**SHA** STATE OF MARYLAND  
DEPARTMENT OF TRANSPORTATION  
STATE HIGHWAY ADMINISTRATION  
OFFICE OF TRAFFIC & SAFETY  
TRAFFIC ENGINEERING DESIGN DIVISION  
**MD 70 (ROWE BOULEVARD)**  
**AT MELVIN AVENUE / FARRAGUT ROAD**

TRAFFIC SIGNAL PLAN	
SCALE 1"=20'	DATE FEB. 12, 1975 CONTRACT NO AA-071X-000-585
DESIGNED BY D. DODA	COUNTY ANNE ARUNDEL
DRAWN BY D. ZAFIRIS	LOGMILE 02007000.98
CHECKED BY A. BUDNICHUCK	T.I.M.S. NO. 1447
F.A.P. NO.	TOD NO.
DRAWING NO. TS-1198J	SHEET NO. 1 OF 3

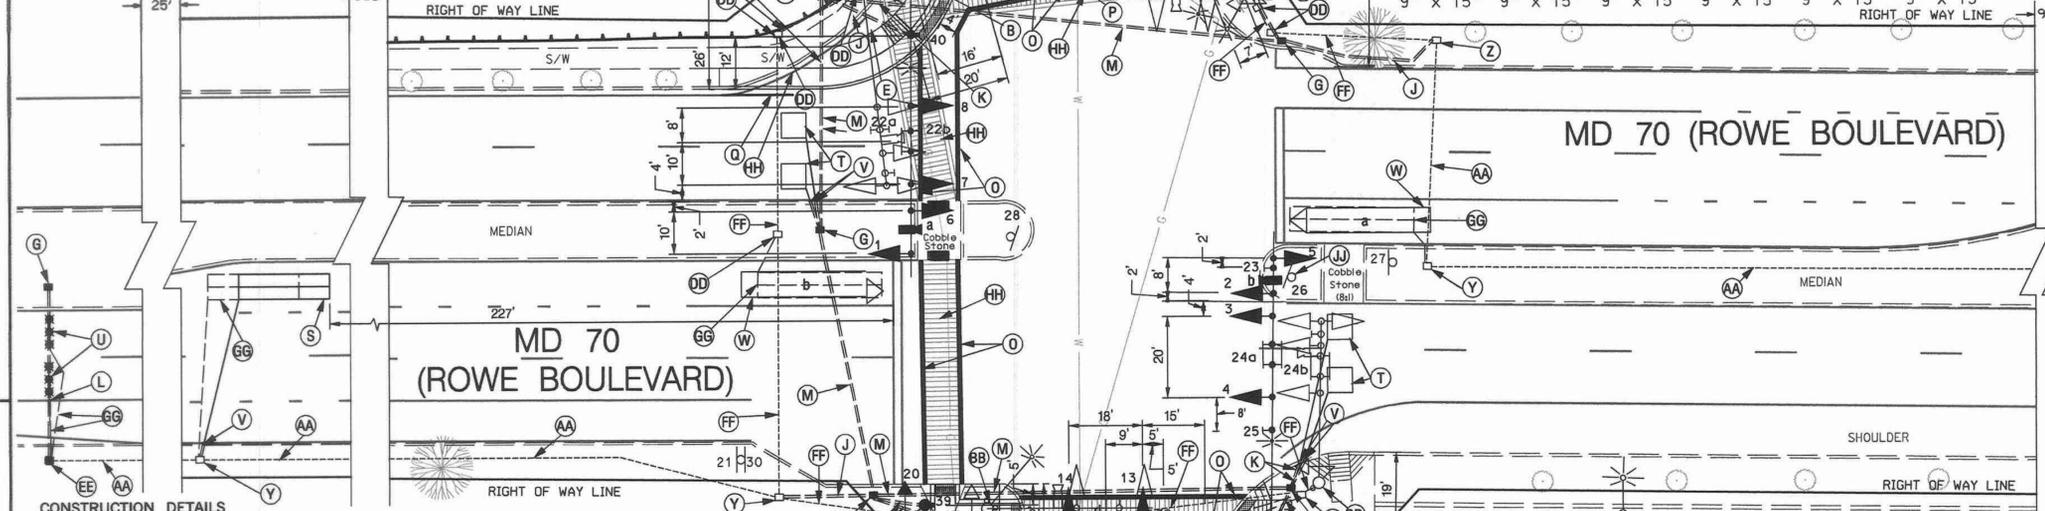
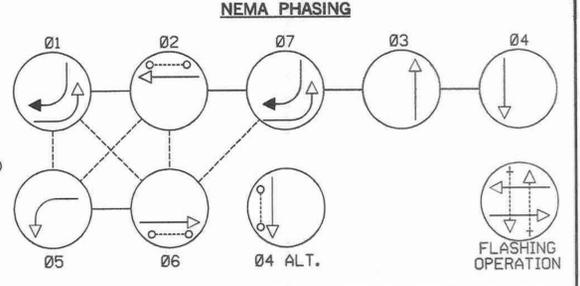
**RED LINE REVISION NO.1 8/18/2010**  
**REMOVE RAMP AND INSTALL CURB TO CLOSE RAMP**  
**TEDD APPROVAL:** \_\_\_\_\_
